SERVICE BULLETIN

NUMBER: 02-170-17R
DATE: 9/11/17
REVISED: 04/23/19

SUBJECT: Oil Leaking from AVCS Oil Control Valve

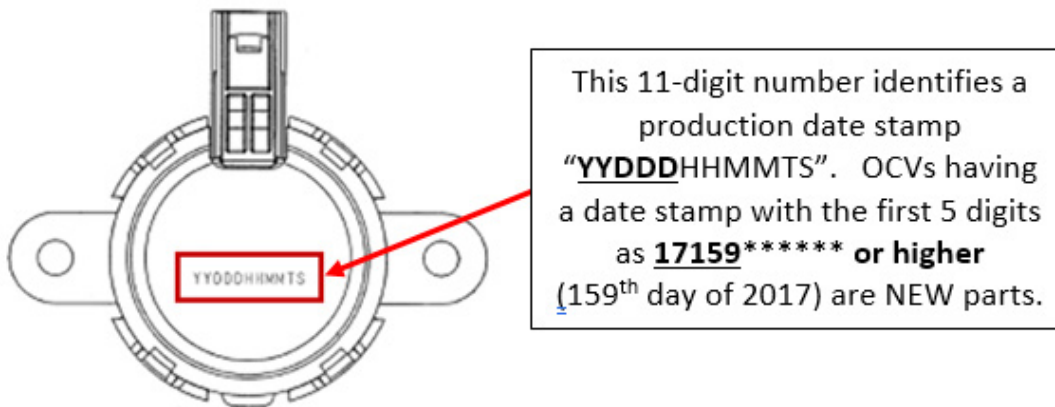
This bulletin announces part information for new Active Valve Control System (AVCS) oil control solenoid valves (OCV) which contain a redesigned internal oil seal. The new seal will eliminate potential oil seepage into the wire harness connector portion of the valve. If oil seeps into the connector, over time, the Check Engine lamp may illuminate and set various AVCS-related DTCs.

New OCVs can be identified by their production lot number located on the face of the solenoid as shown in the illustration below.

Description	NEW Part Number	OLD Part Number
VALVE ASSEMBLY-OIL CONTROL	10921AA231	10921AA230
	10921AA241	10921AA240
	10921AA23B	10921AA23A

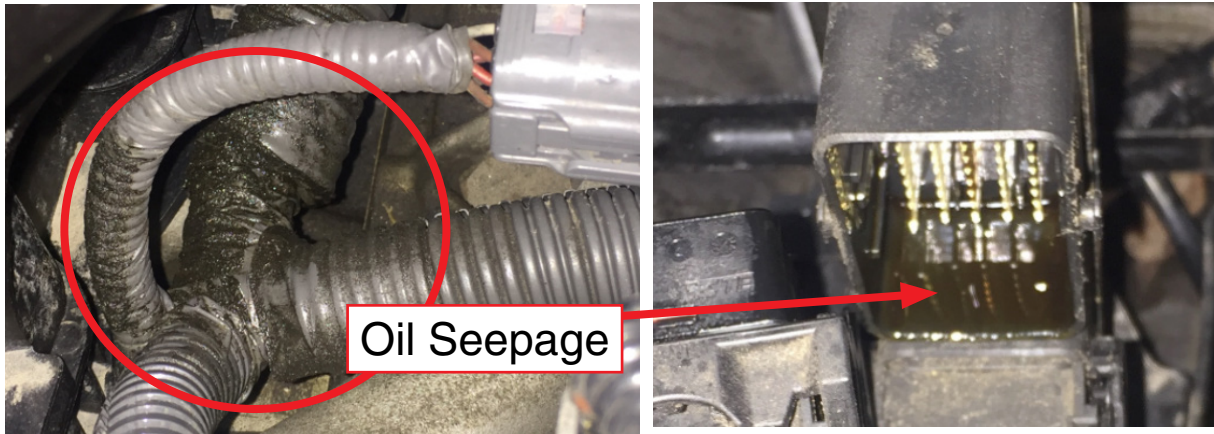
There have been a small number of reports involving engine oil “wicking” past the OCV engine harness connector and into the related wiring harnesses and connectors as shown in the photos below.

If oil is found in the harness connector during diagnosis of AVCS-related DTCs, replace the affected OCV with a new part as listed in the parts information supplied above. Follow the service procedures as outlined in the applicable Service Manual.

If related engine wiring harnesses and / or connectors are contaminated, the harness itself may also need to be replaced if degreasing affected components using a spray parts cleaner is unsuccessful.
